# ORINATION FORM

## Proposed Revisions to the Specifications

**STRUCTURAL STEEL AND MISCELLANEOUS METALS**  
**(REV 7-5-22)**

SUBARTICLE 460-1.2 is deleted and the following substituted:

**Figure 266.23.1 Pedestrian or Shared Use Path Bridge Typical Section**

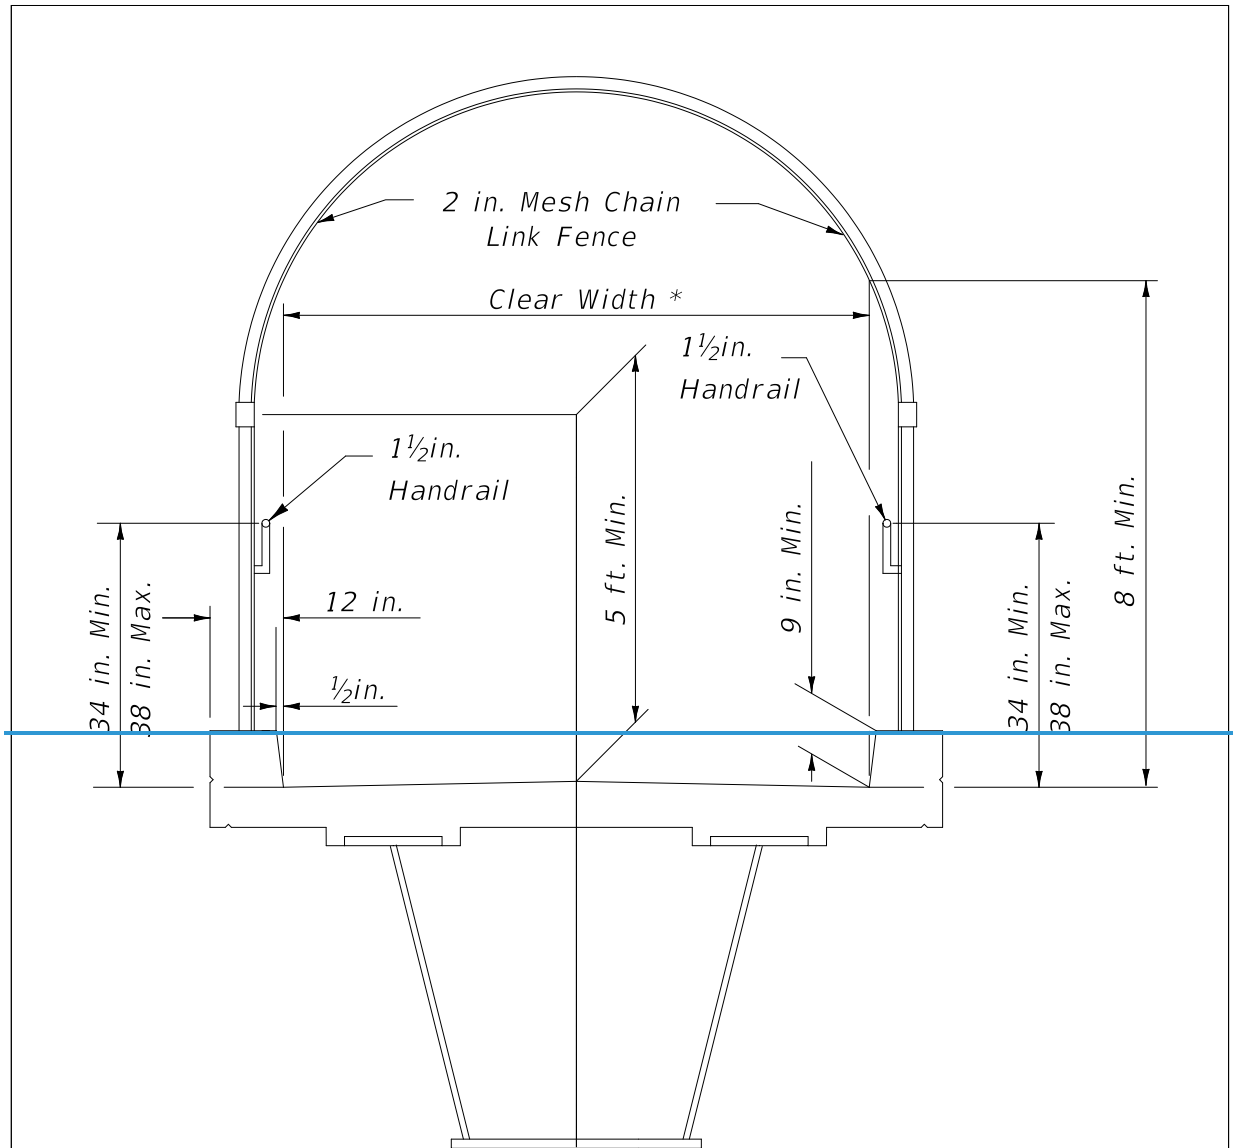
- (b)** Provide full or partial screening on pedestrian bridges crossing FDOT right of way in order to reduce the likelihood of objects being dropped or thrown onto the roadway below. See **Figure 266.23.1** for example of full screening.

Coordinate with District Design Engineer and local stakeholders to determine use of full screening on pedestrian bridges crossing FDOT right of way. When fencing is required, make the limits of fencing from the beginning of the approach slab at Begin Bridge to the end of approach slab at End Bridge.

**Figure 266.34.12** Prefabricated Pedestrian Bridge Standard Truss Configurations

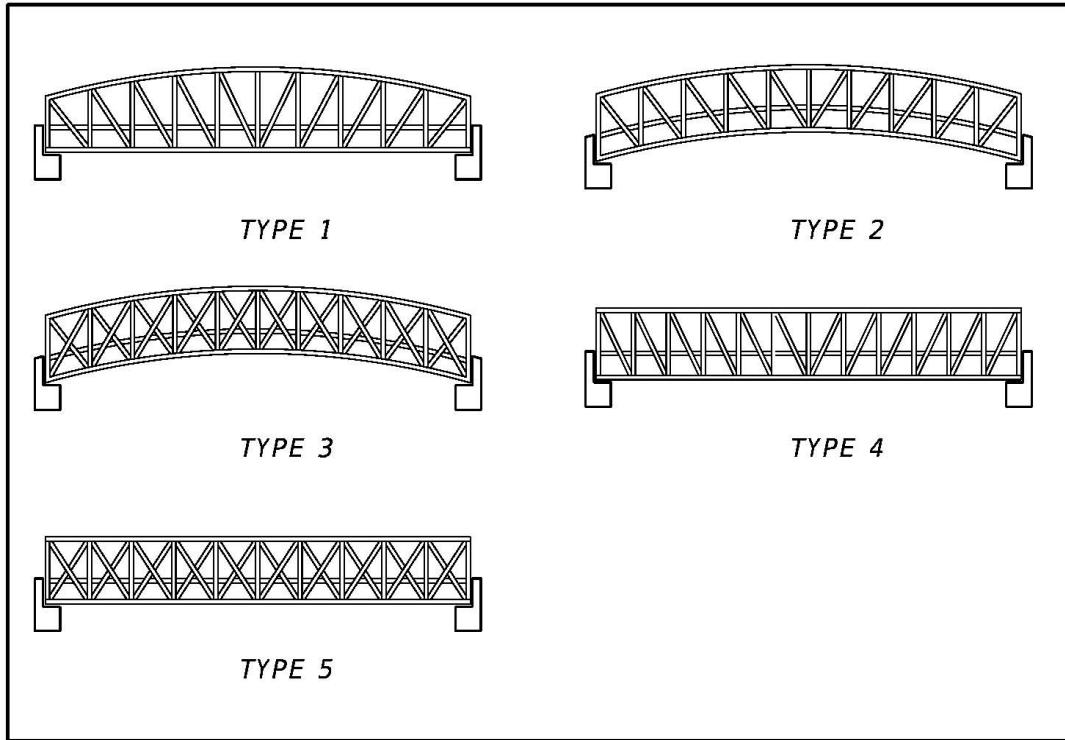
- (1) Using **Figures 266.34.12**, **266.34.23**, and **266.34.34**, coordinate with the District Project Manager to select allowable truss configurations, truss member shapes, and bridge cross sections. A box truss bridge cross-section is required for spans greater than 150 feet.

If project specific aesthetic requirements warrant the use of truss configurations not included in **Figure 266.34.12** the project EOR can specify additional truss configurations. However, a minimum of two steel truss pedestrian bridge producers must be capable of satisfying the aesthetic requirements.
